Work Order ID 152883

DART SERVICE INSTRUCTION

TO AMEND INSTALLATION INSTRUCTIONS D350-607-3 Rev.D,

REF TCCA STC: SH94-14

FIGURE 1: INSTALLATION OF D4775-041 FWD STRUT

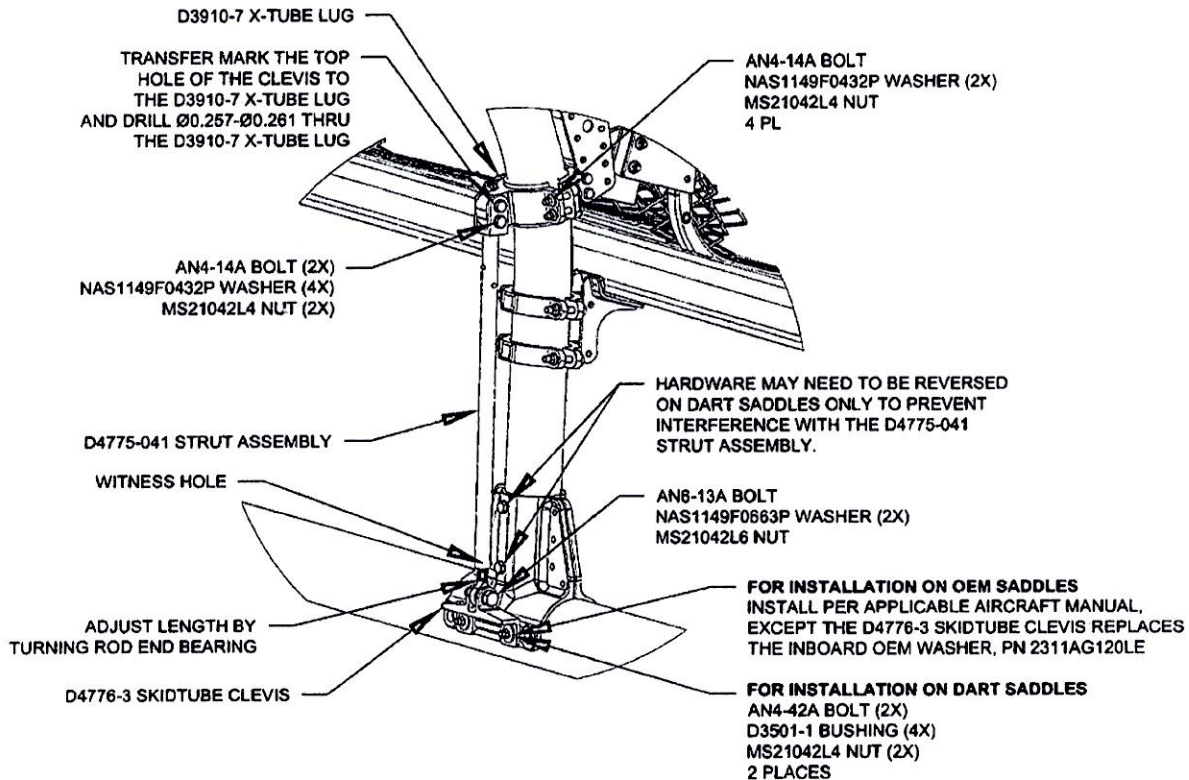
3.1 Substitute the Forward Lower D3910-5 X-Tube Lug with the D3910-7 X-Tube Lug as shown in Figure 1.

3.2 Install the forward D4775-041 Strut Assembly. Transfer mark from the upper hole on the clevis of the D4775-041 Strut Assembly to the D3910-7 X-tube Lug and drill thru the lug $\varnothing 0.257$ - $\varnothing 0.261$ as shown in Figure 1. Touch up chemical conversion coating per MIL-DTL-5541. Check the witness holes located at the bottom end of the D4775-041 Strut Assemblies to ensure that the thread from the rod end extends past the witness hole.
Torque MS21042L4/-4 nuts to 50-70 in-lbs (5.7-7.9 N-m). Torque MS21042L6/-6 nuts to 160-190 in-lbs (18.1-21.5 N-m).
